**BEFORE AN INDEPENDENT HEARING PANEL
APPOINTED BY QUEENSTOWN LAKES DISTRICT COUNCIL**

IN THE MATTER of a Variation to the proposed Queenstown Lakes District Plan (Te Pūtahi Ladies Mile) in accordance with Part 5 of Schedule 1 to the Resource Management Act 1991

**STATEMENT OF EVIDENCE OF TIMOTHY JOHN CHURCH – UBRAN DESIGN
ON BEHALF OF THE ANNA HUTCHINSON FAMILY TRUST**

DATED: 20 OCTOBER 2023

Figure 1a: Excerpt from TPLM Masterplan 'Existing Constraints' with keynote 5 identifying poor connectivity to the existing travel network (pg 30) - note: red circle added for emphasis

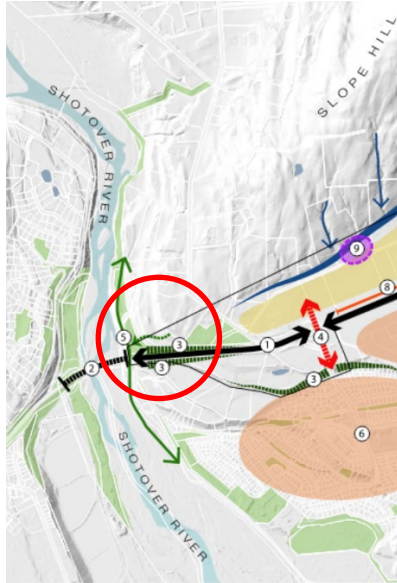
23. Mr Harland summarises in his evidence the existing opportunities identified within the Te Pūtahi / Eastern Corridor. He notes relevant constraints in paragraph 47(a)(iv), including '*poor connectivity to the existing travel network*' and relevant opportunities in paragraph 47(b)(iv) - (v), including '*Create links to existing trails*' and '*Connect existing residential neighbourhoods to new development and amenities*'. These are illustrated on pages 30 and 31 of the TPLM Masterplan, keynoted as 5 and 4 and 7 on the constraints and opportunity plans, respectively, with excerpts illustrated in Figure 1 below. I have assumed that these plans indicate several constraints and opportunities identified through the Council's masterplanning process that are closely associated with the proposed Extension Area, which I both agree with and consider relevant to the Trust's submission. However, to my knowledge these have not been explicitly addressed in the TPLM Masterplan or Structure Plan. Again, these are addressed in more detail later in my evidence.

Figure 2: Queenstown Lakes Spatial Plan (Map 7: Wakatipu – Spatial Elements) with an overlay of the Te Pūtahi Ladies Mile Variation Area and Extension Area boundaries illustrating they are within the frequent public transport corridor with parts of the western future urban areas excluded.

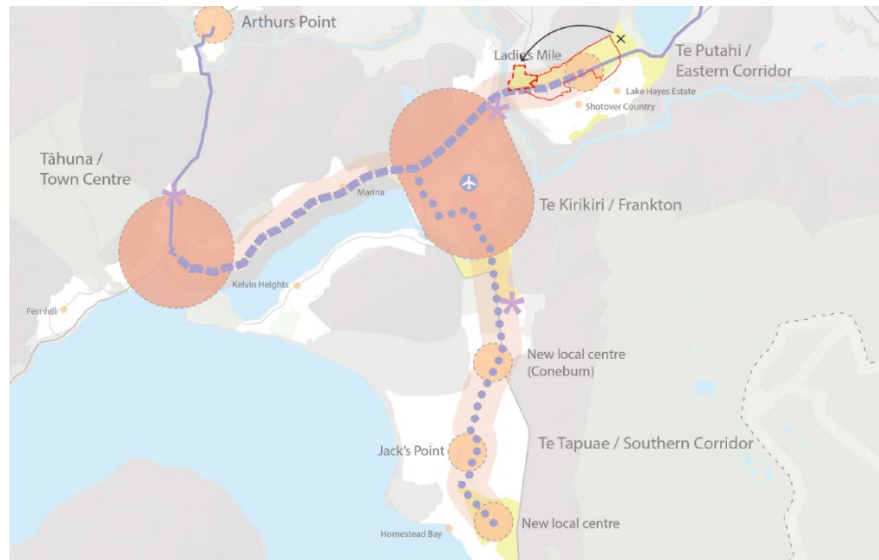
38. Notwithstanding the evidence provided on land use demand elsewhere, it is noted that future urban areas at the western end of the of the Corridor have now been excluded from the TPLM Structure Plan and I consider there is an opportunity to reallocate this potential for urban development to a more accessible location, such as the Extension Area, as indicated in Figure 2.
